CEC submission for Vivian Silica Sand Extraction Project

D.M. LeNeveu, M.Sc. (biophysics). B.Sc. (honours physics), B.Ed.

Feb. 13, 2023

Figure 37. Sio Silica revised Extraction Plan of Jan. 24, 2023.
 Reproduced from Sio Silica letter from Jesse Baker of Osler Law to the CEC.

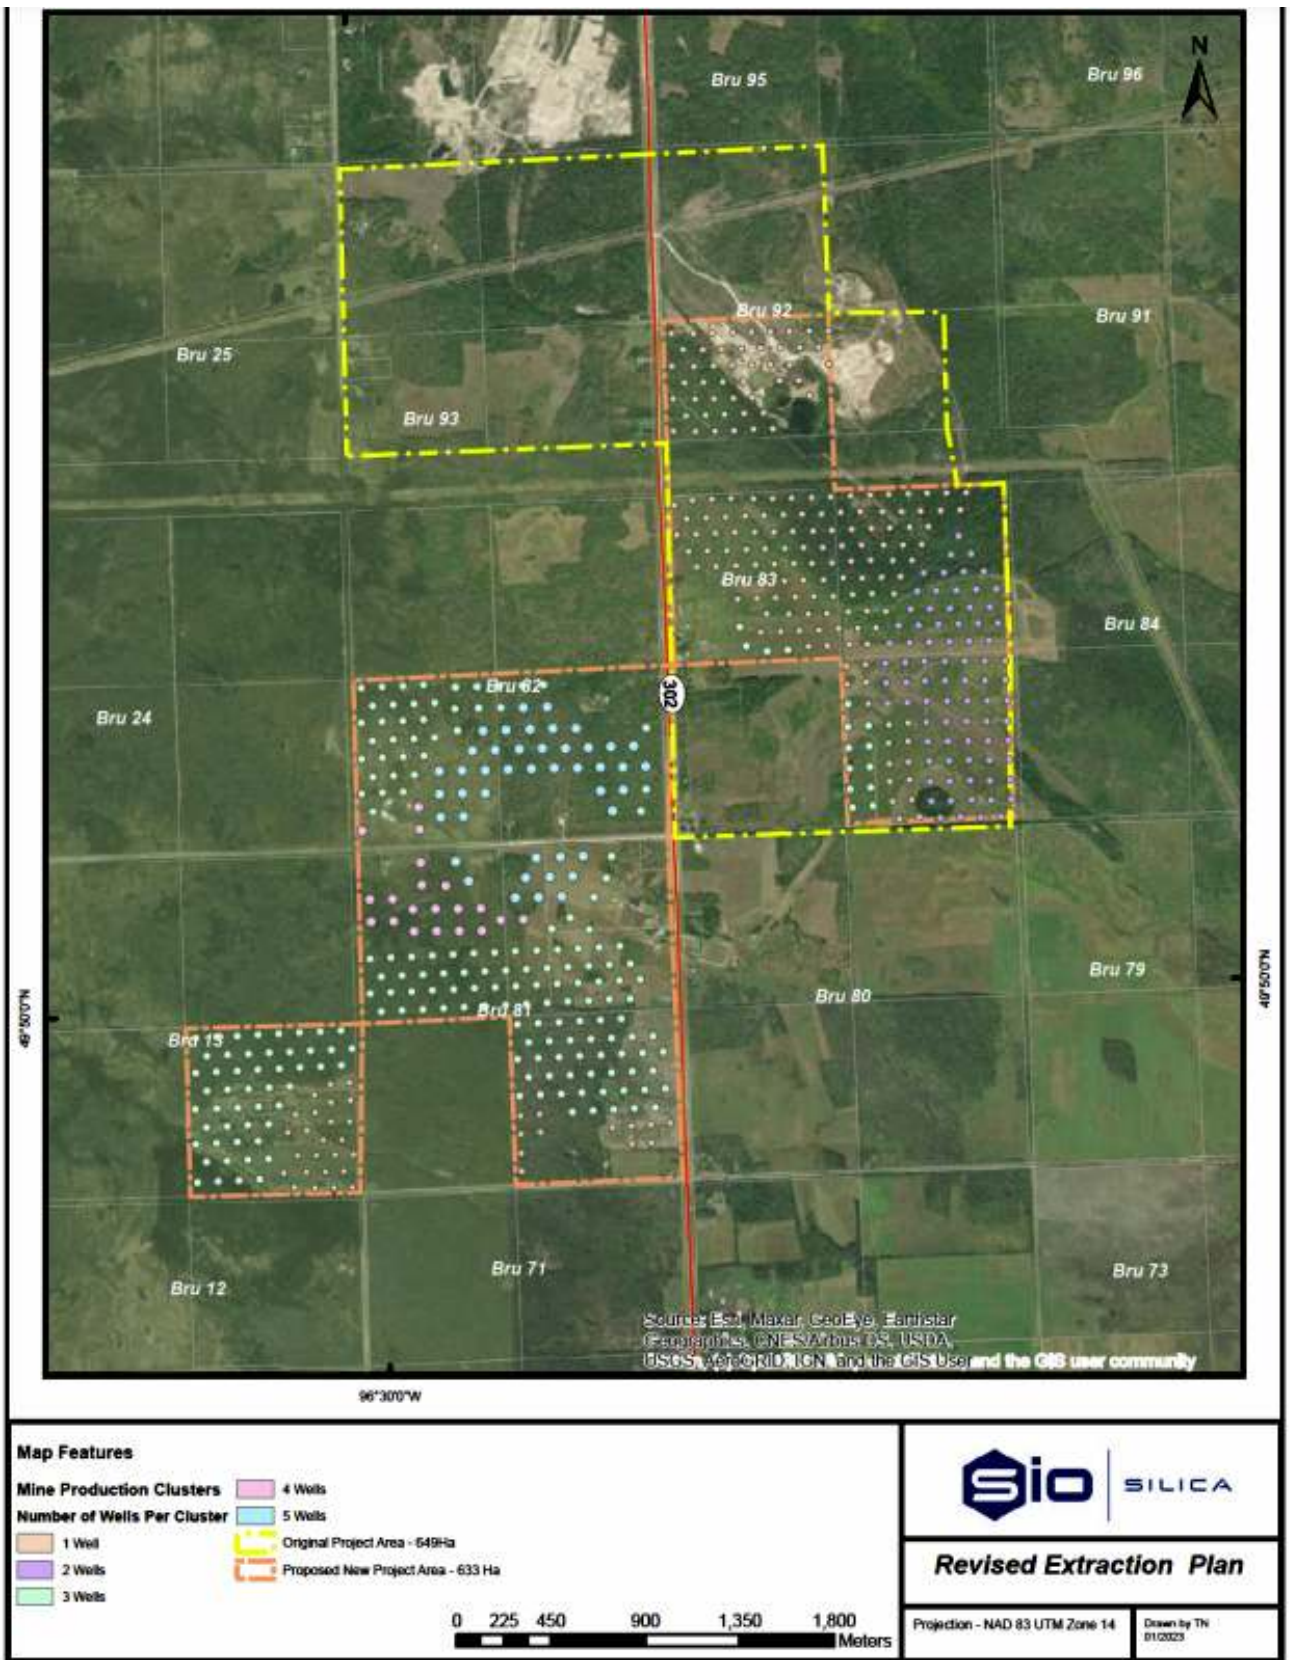
Attachment A of the revised extraction plan reproduced in Figure 37 does not contain information on the revised cluster cavity spans, cluster spacing, the year of extraction and the number of wells for each extraction year.

Figure 44. Selenium concentration in the Sio Silica recycling loop water
Illustration from modelling by D.M. LeNeveu

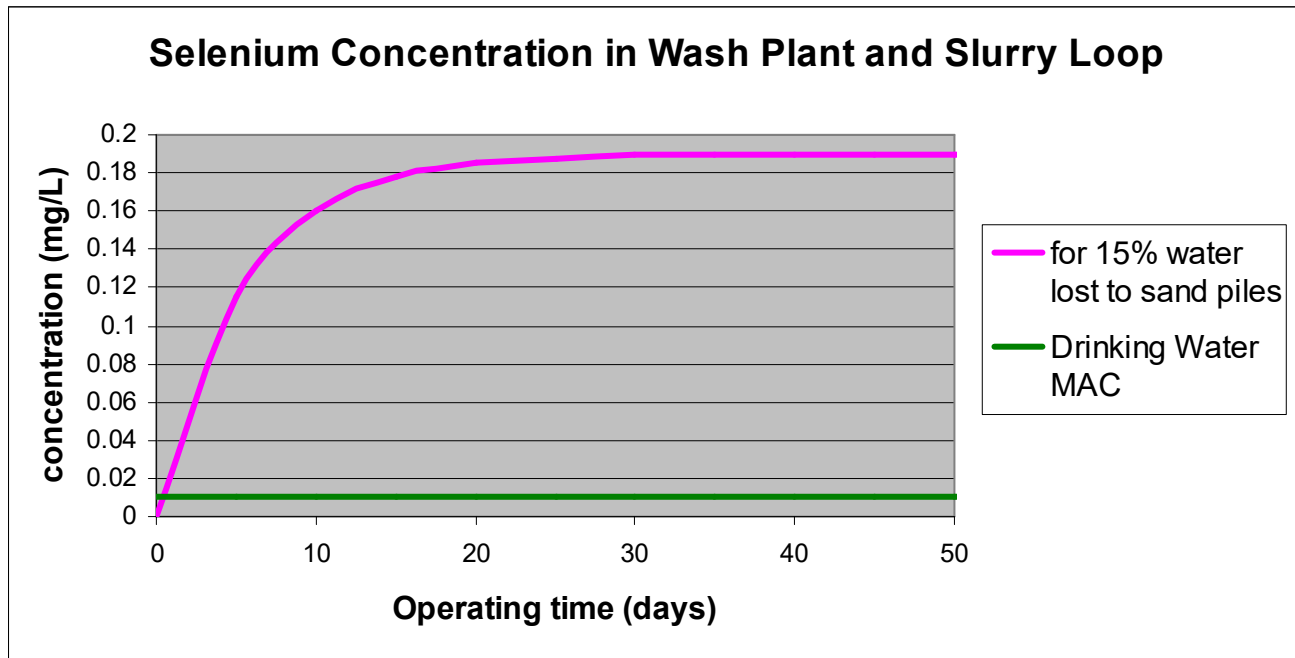
Figure 44 illustrates that the selenium concentration would rise to steady state in the water recycling loop in about 20 days and would exceed drinking, irrigation and aquatic life water guidelines in a matter of hours. Remediation by a contaminant removal process such as reverse osmosis would be required to operate continuously. Sio Silica must specify the volume, disposal method and disposal location of the concentrated selenium waste stream.

Figure 49. Location of MB Hydro Pointe du Bois power line, the MB Hydro 500 kV international transmission line, Winnipeg aqueduct and CN mainline.⁷⁵

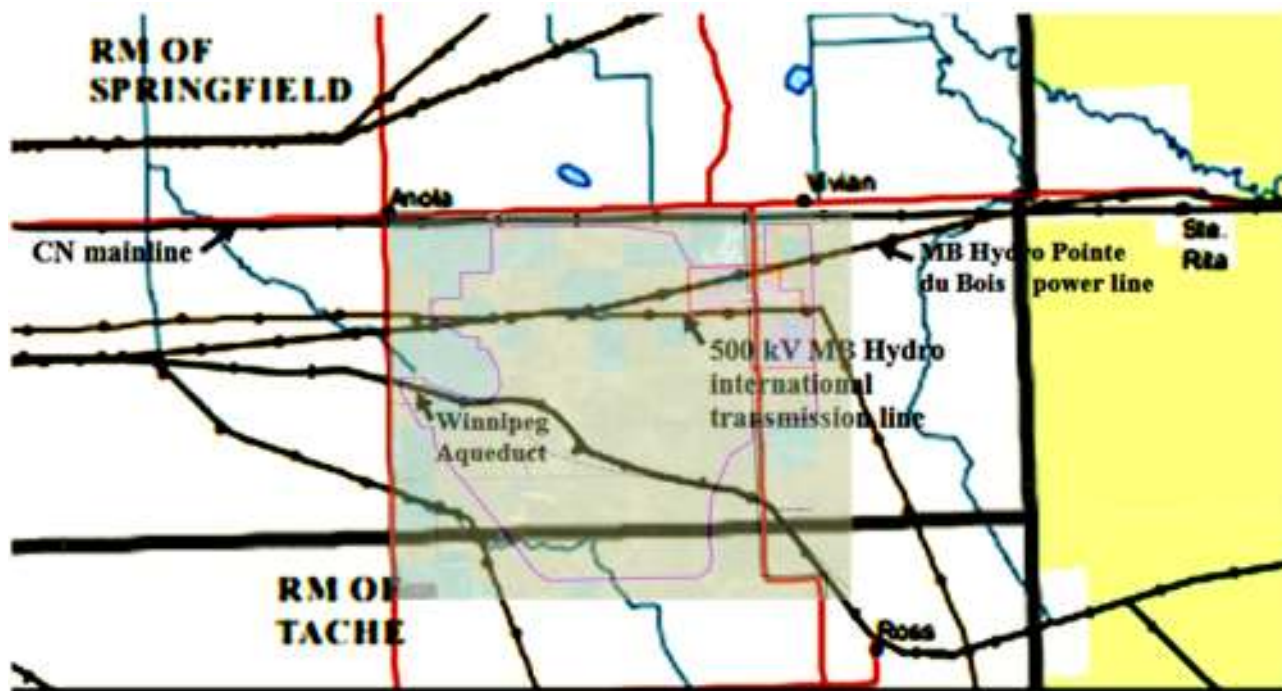
Figure 49 illustrates the land disturbance that would affect the international 500kV transmission line and the Pointe du Bois power line due to land subsidence. The unconsolidated sand around the cavities would slump into the cavities gradually enlarging the area of the unsupported shale and limestone above. The limestone is not thick enough to support the cavities that would increase in size as the sand slumps. The land subsidence could cause the formation of swamps or wetlands around and crossing the hydro corridors. The subsidence would cause land depression and instability within and adjacent to the corridors and transmission lines.

As shown in figure 49 the Sio Silica well clusters up until 2025 would be on either side of the provincial highway 302. Sio Silica slurry lines and heavy equipment such as vacuum trucks and drill rigs would be required to cross highway 302. To our knowledge Sio Silica has not notified Manitoba Infrastructure nor obtained permission for the disturbance to highway 302. The land subsidence that could occur from the well clusters could destabilize the road bed and would affect road drainage. Sio Silica should have identified these engineering issues and documented the risks and planned mitigation.

As shown in figure 49 the Winnipeg aqueduct traverses the entire Sio Silica project area. Eventually the slurry lines and return recycled water loops would eventually likely have to cross the aqueduct multiple times. The aqueduct is known to have cracks that allow infiltration of surface water.⁷³ Slurry line spills near the aqueduct could contaminate Winnipeg’s drinking water supply with harmful microbes, arsenic, selenium, other heavy metals and the highly toxic acrylamide monomer. A major break of the slurry line would leak at a rate of up to 24 cubic meters per minute as documented in the Sio Silica processing plant EAP. The aqueduct could be submerged with a volume of about an Olympic sized swimming pool in two hours. A gradual undetected leak could infiltrate the aqueduct undetected for a long time. The land subsidence and wetlands created by the well clusters on either side of the aqueduct could destabilize the aqueduct and adversely affect drainage around the aqueduct. Flooding of the aqueduct from subsidence wet lands could occur.
